REPORT TO DESIGN COMMISSION City of Sacramento

PUBLIC HEARING
September 15, 2010

Subject: 3820 Broadway (P10-042) Located at the southeast corner of Broadway and Martin Luther King Jr, Boulevard, a request to develop a three story 56 unit residential with ground floor retail on 1.2+/- acres in the Broadway/Stockton and Oak Park Special Planning District (C-1-SPD) zone.

PRELIMINARY LANDSCAPE PLAN

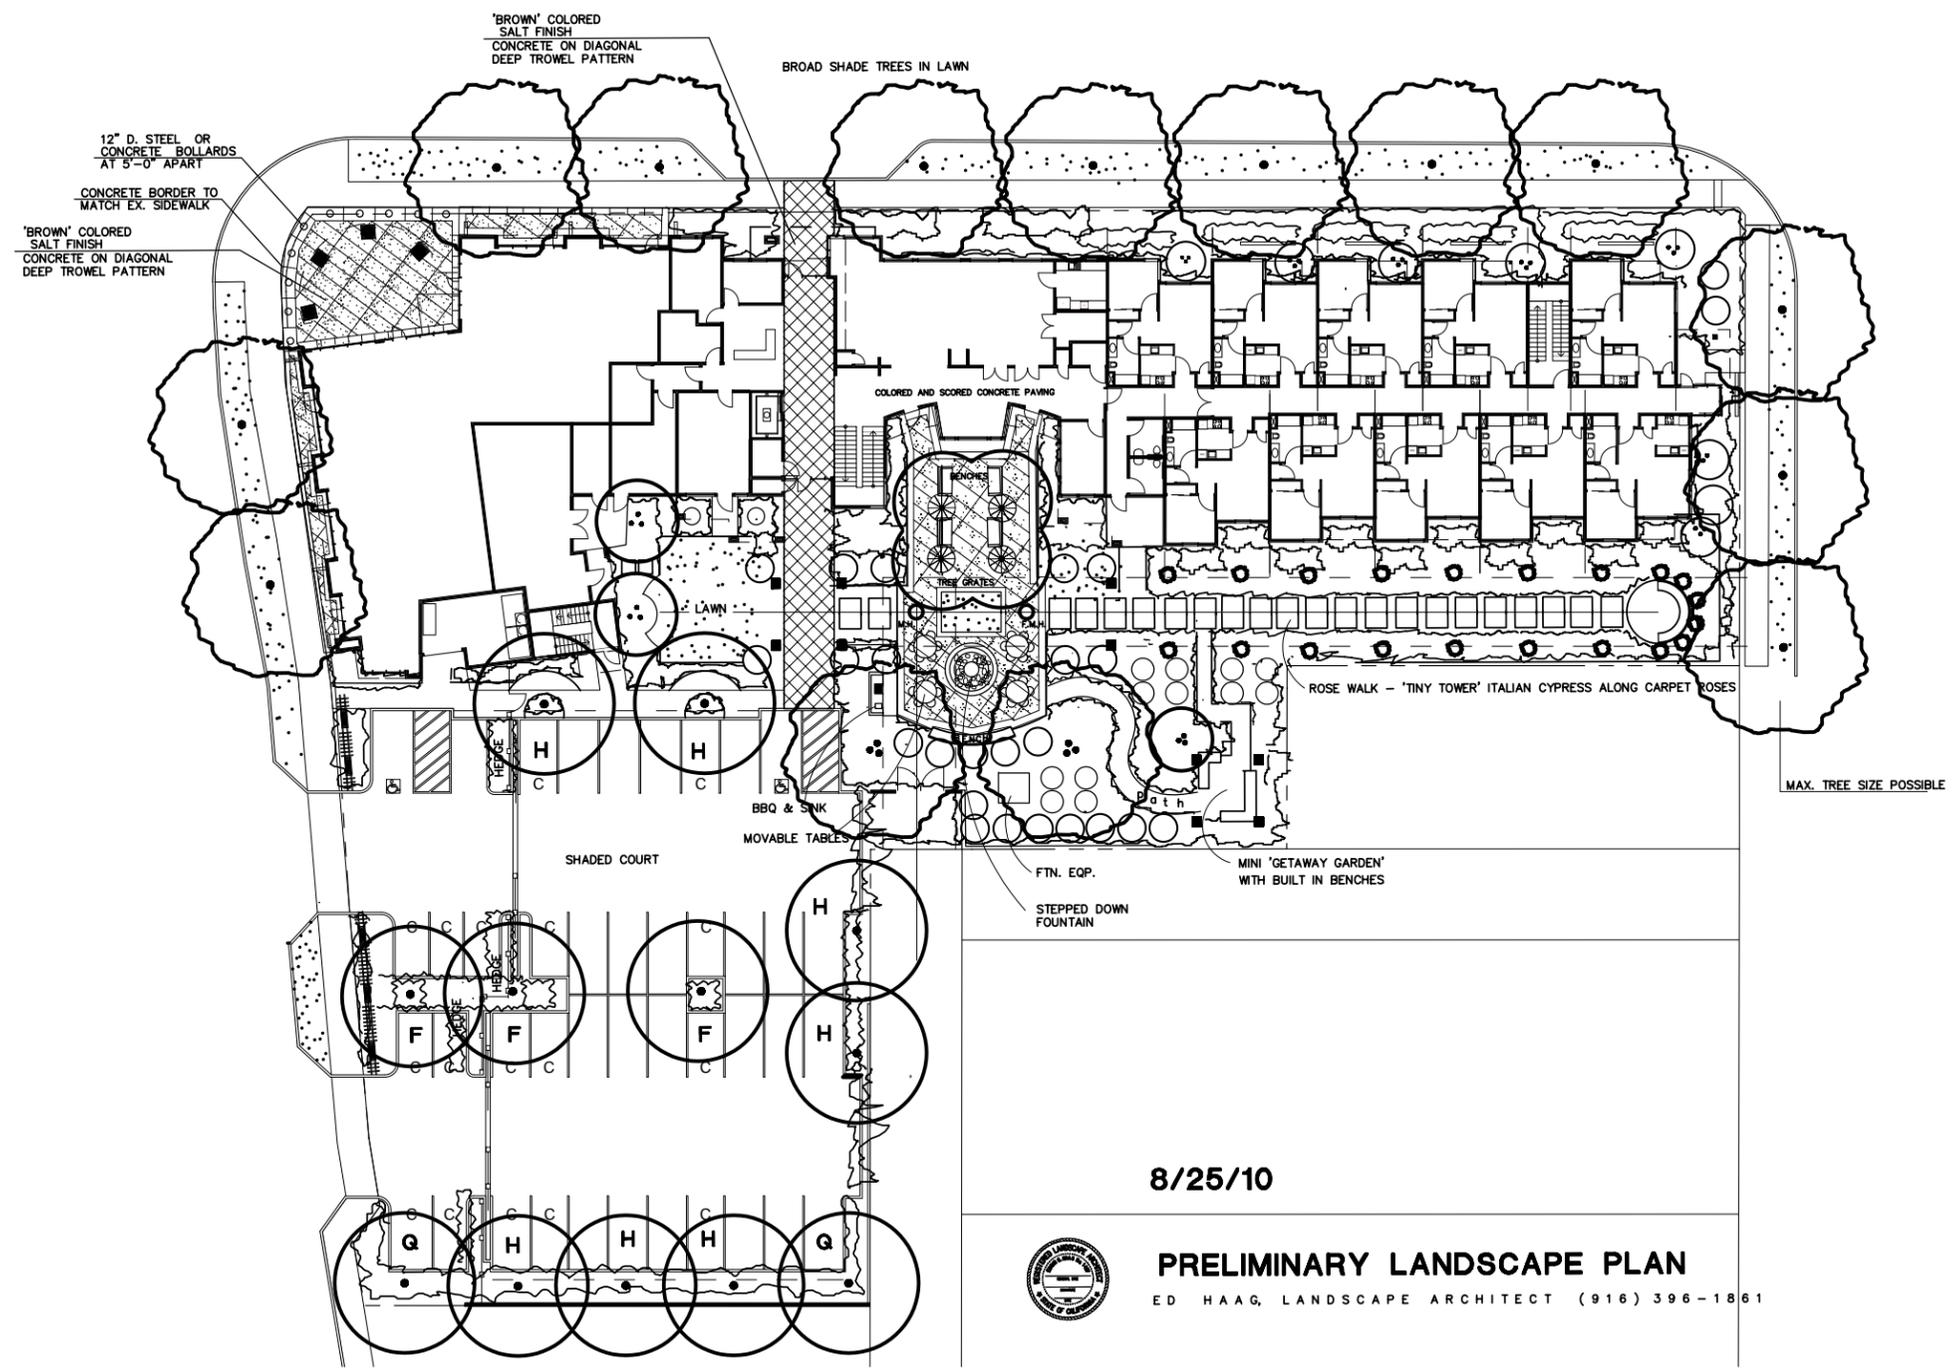
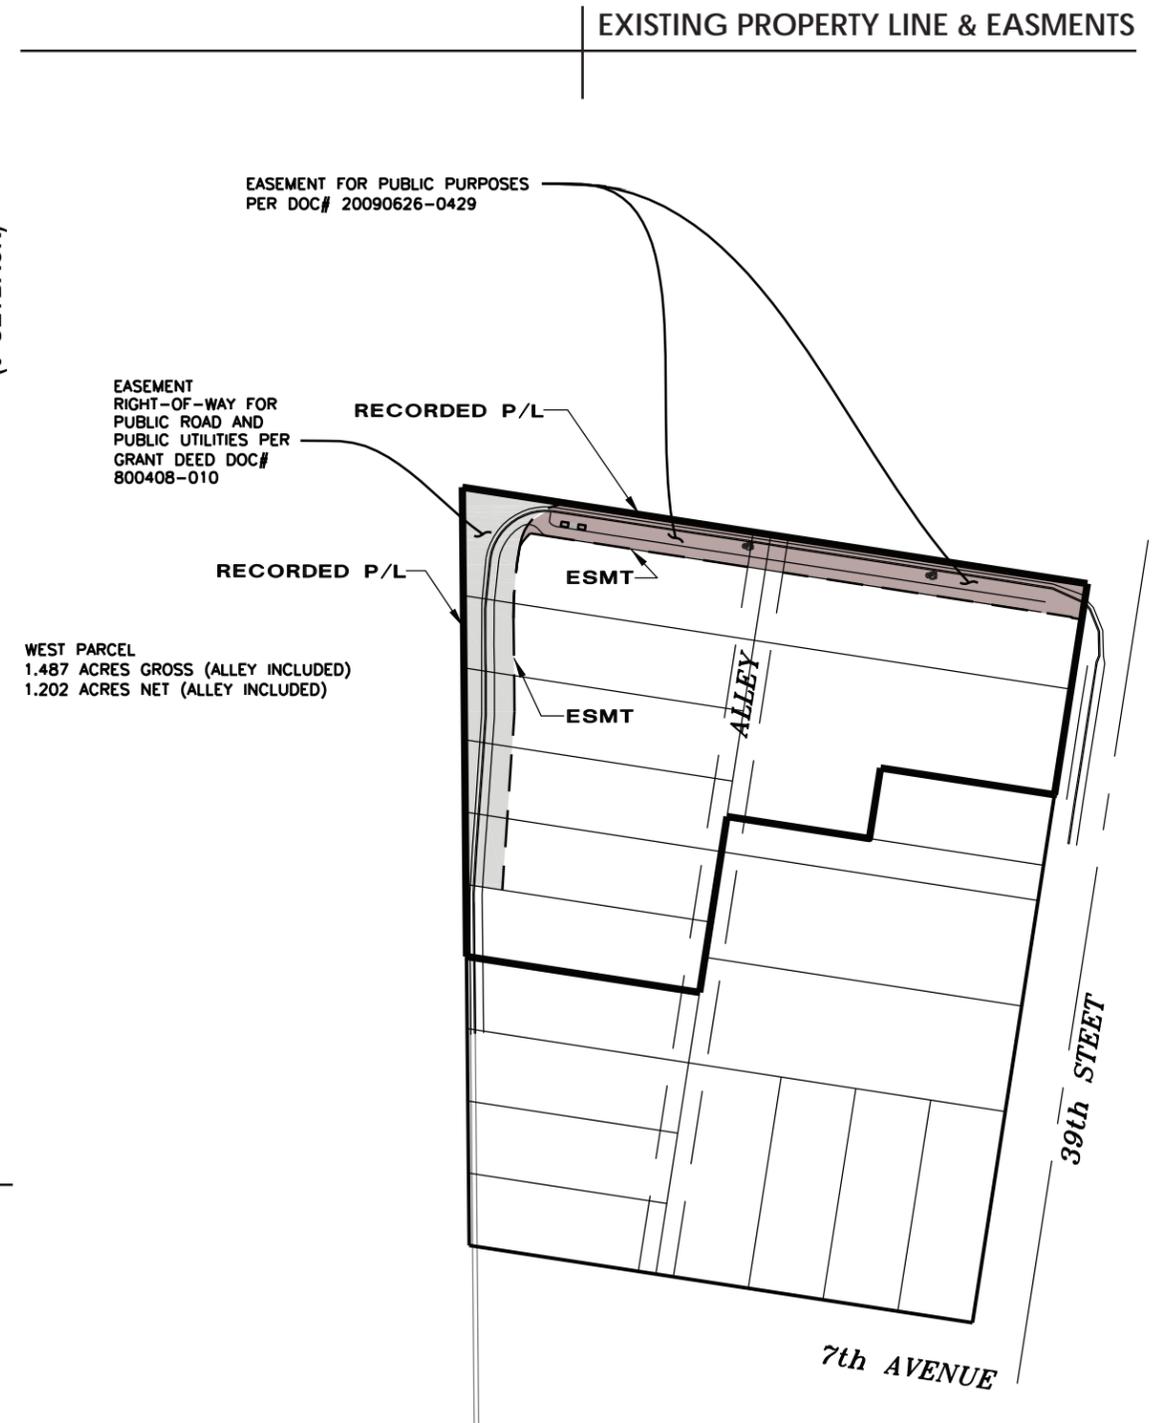
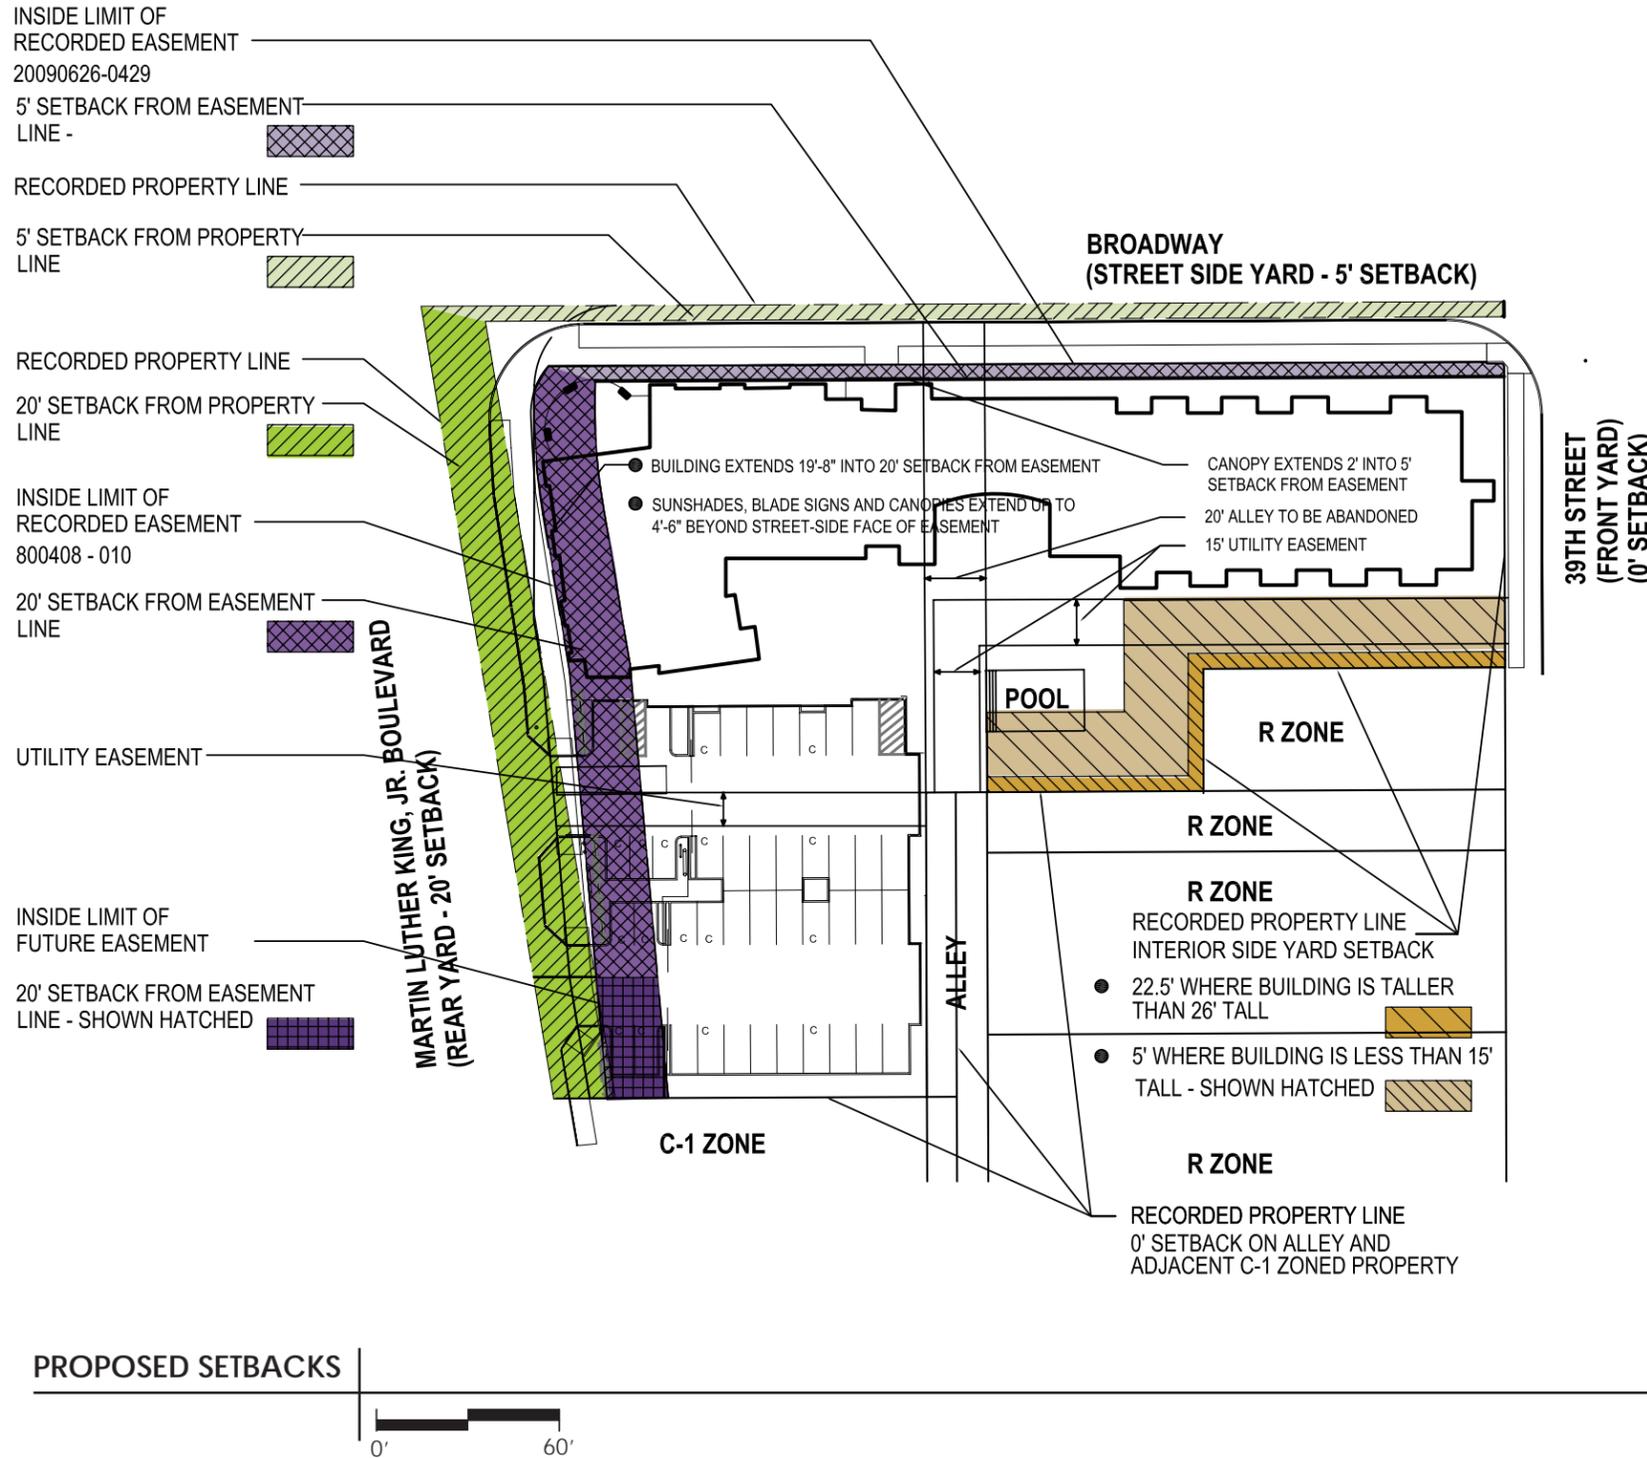
5. A separated sidewalk and generous street planters have been provided to replace the existing sidewalks. The applicant has provided additional landscaping along the Broadway elevation at the main pedestrian entry and both in front of and behind the residential separation walls. The largest possible canopy trees have been called out for 39th Street street edge, and the applicant will work with Urban Forest staff on final determination on species. The parking area has been reconfigured to provide 50.5% shading ratio, and conforms to the 50% shading requirement for parking. Staff is supportive of the revisions to the landscaping and parking shading.

5. A separated sidewalk and generous street planters have been provided to replace the existing sidewalks. Large canopy street trees will be provided along Broadway and Martin Luther King Jr. Boulevard, but the street planters along 39th Street can only accommodate a medium canopy shade tree per the City standards. Staff recommends working with Urban Forest Staff on the proper selection of trees along 39th Street. The parking area currently provides a 42% shading ratio, staff requires that the project meet the 50% shading requirement. **Staff recommends that the Design Commission comment on the adequacy of landscaping provided.**

6. A substantial amount of landscaping has been provided on the proposed project. Staff supports the design provided, but recommends relocating the water feature north into the lawn area providing a better focal point for those walking down the Rose walk. Staff would like some additional detail or enlarged plans describing what type of materials and amenities will be provided in the rear landscape area provided at the review and comment hearing. Staff recommends that the barbeque area be relocated to the south of the water feature where the bench area is currently located, as this will provide an area that intentionally appears to activate the space and some additional screening of the proposed fountain equipment located to the south. **Staff recommends that the Design Commission comment on the adequacy of landscaping provided.**

BROADWAY ELEVATION

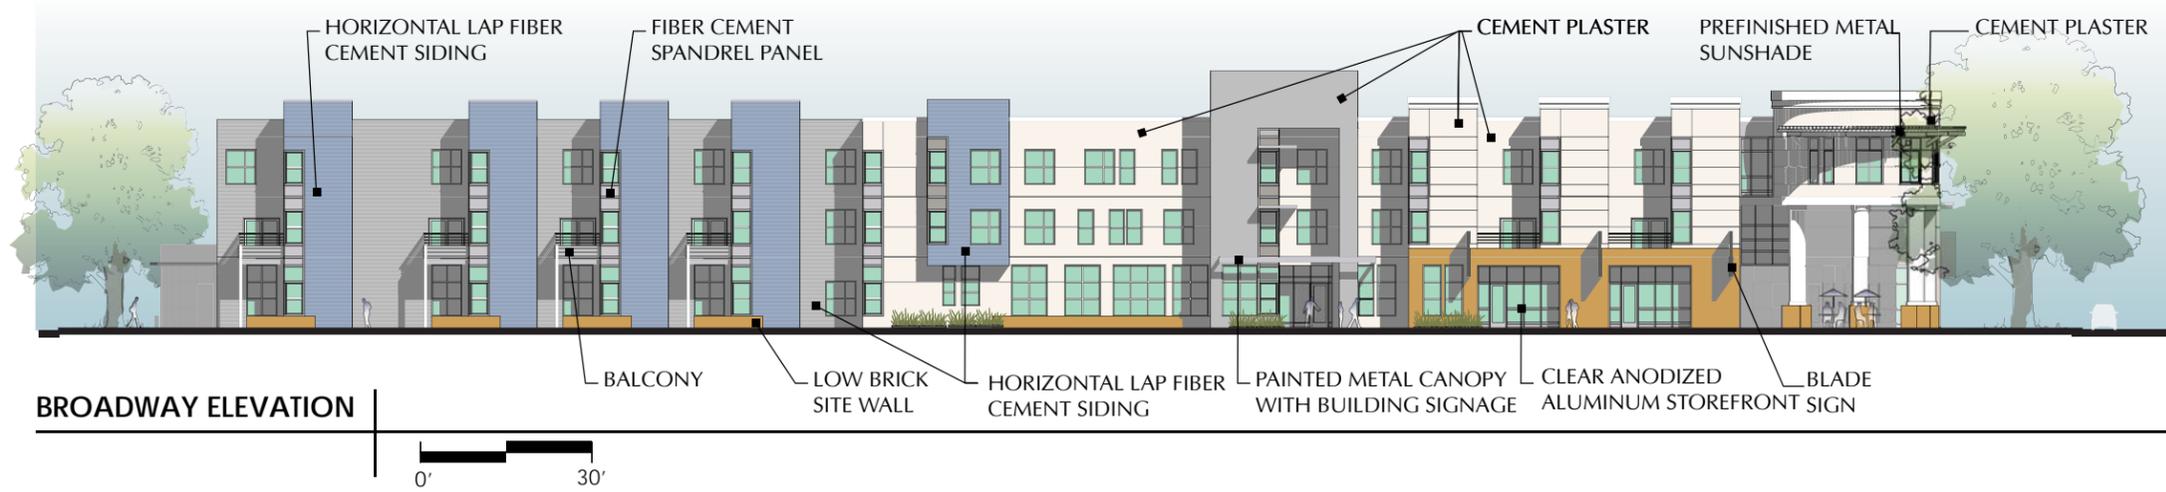
4. The Broadway elevation needs a better relationship between styles and elements at the corner as they seem disparate. The massing of the column bases appear over scaled and could use some further study and refinement.

5. Blue vertical residential elements along Broadway appear too dark and could use some lighter colors.
6. Monolithic color scheme at the courtyard area is supported by the Commission.

13. The general composition and variety of the fenestration is acceptable, but a small section to the east of the entry at the second and third floors appears to depart from any established rhythm. **Staff feels that the second and third floor fenestration should be aligned to better complement established patterns, and requests the Design Commission provide their recommendations regarding this area of fenestration.**
